PHAP15-00007

Date: February 23, 2015
Application Type: Certificate of Appropriateness
Property Owner: The Venice Group
Representative: Carlos Silveyra
Legal Description: Being Fr. 7 Alexander 9 & 10, City of El Paso, City of El Paso, El Paso County, Texas
Historic District: Sunset Heights
Location: 1319 N. El Paso Street
Representative District: #8
Existing Zoning: A-3/H (Apartment/Historic)
Year Built: 1930
Historic Status: Non-Contributing
Request: Certificate of Appropriateness for the removal and replacement of doors and windows and the installation of through-wall grilles after-the-fact
Application Filed: 2/9/2015
45 Day Expiration: 3/26/2015

ITEM #2

Certificate of Appropriateness for the removal and replacement of doors and windows and the installation of through-wall grilles after-the-fact

PHOTOGRAPHS OF THE PROPERTY

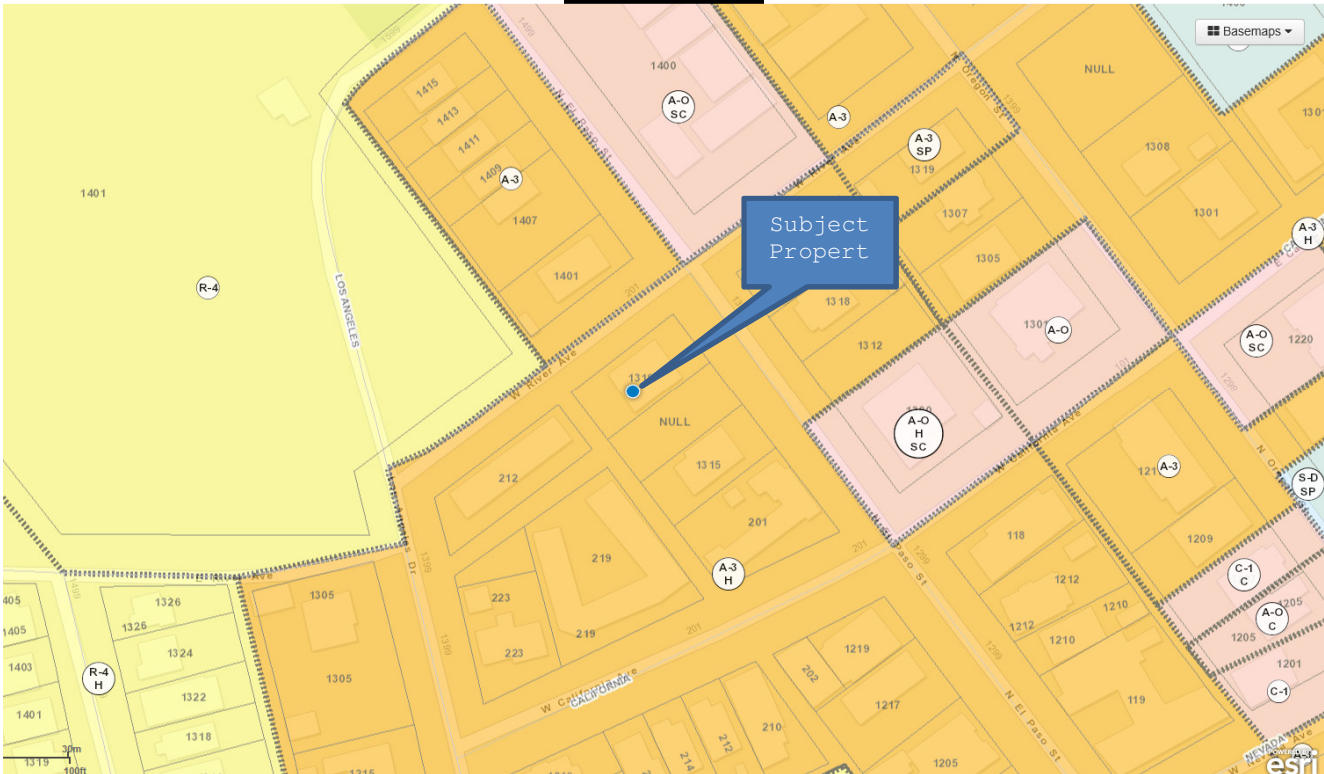
The Historic Preservation Office recommends DENIAL of the proposed scope of work based on the following recommendations:
